# Technical information

TI No.: 75.00U21166A Distribution list: D Distribution date:

TITLE: S 417 TC, S 407 CC - Fitting arrester cables to the engine

compartment flap

M88.40-A001-74

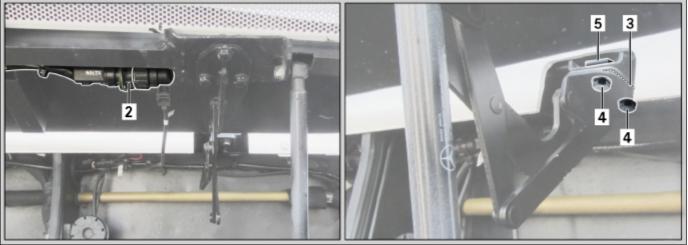
3. Disconnect the electrical connection on right-hand flap side (2).

## Note

This operation does not apply on the left-hand side.

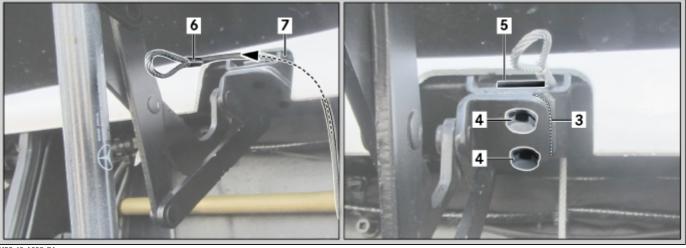
- 4. Mark **(3)** the installation position of the flap hinge on the vehicle bracket by suitable means (e.g. white permanent marker).
- 5. Unscrew (4) the flap hinge from the vehicle bracket.

6. Remove inserted threaded hole plate **(5)**.

- M88.40-A002-74
- 7. Slide the loop of arrester cable **(6)** through vehicle bracket **(7)** from the rear.
- 8. Insert threaded hole plate (5).
  - i Note

The arrester cable must run to the right of the threaded hole plate. This also applies to installation on the left-hand side.

M88.40-A003-74

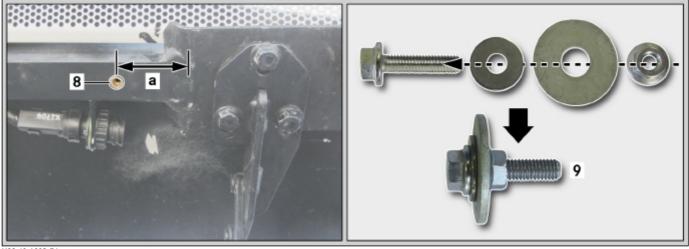
9. Screw on **(4)** the flap hinge aligned on applied marking **(3)** on the vehicle bracket.

10. Using a twist drill bit (Ø **7.5 mm**), drill a hole in the frame of the engine compartment flap, deburr and apply corrosion inhibitor.

This operation does not apply on the left-hand side. The bore hole is already present.

M88.40-A004-74

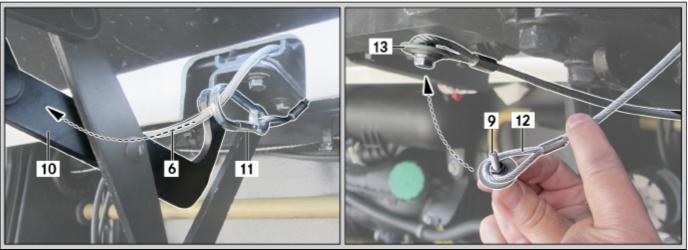
- 11. Fit blind rivet nut (8).
- 12. Preassemble securing screw (9) for the arrester cable with washers and nut.

13. Guide arrester cable **(6)** above flap hinge **(10)** to the fastening point.

- 14. Place loop (12) of the arrester cable around preassembled securing screw (9).
- 15. Screw (13) the arrester cable onto the frame of the engine compartment flap.

- 16. Secure arrester cable **(6)** using snap hook **(11)**.
- 17. Establish the electrical connection on right-hand flap side (2).
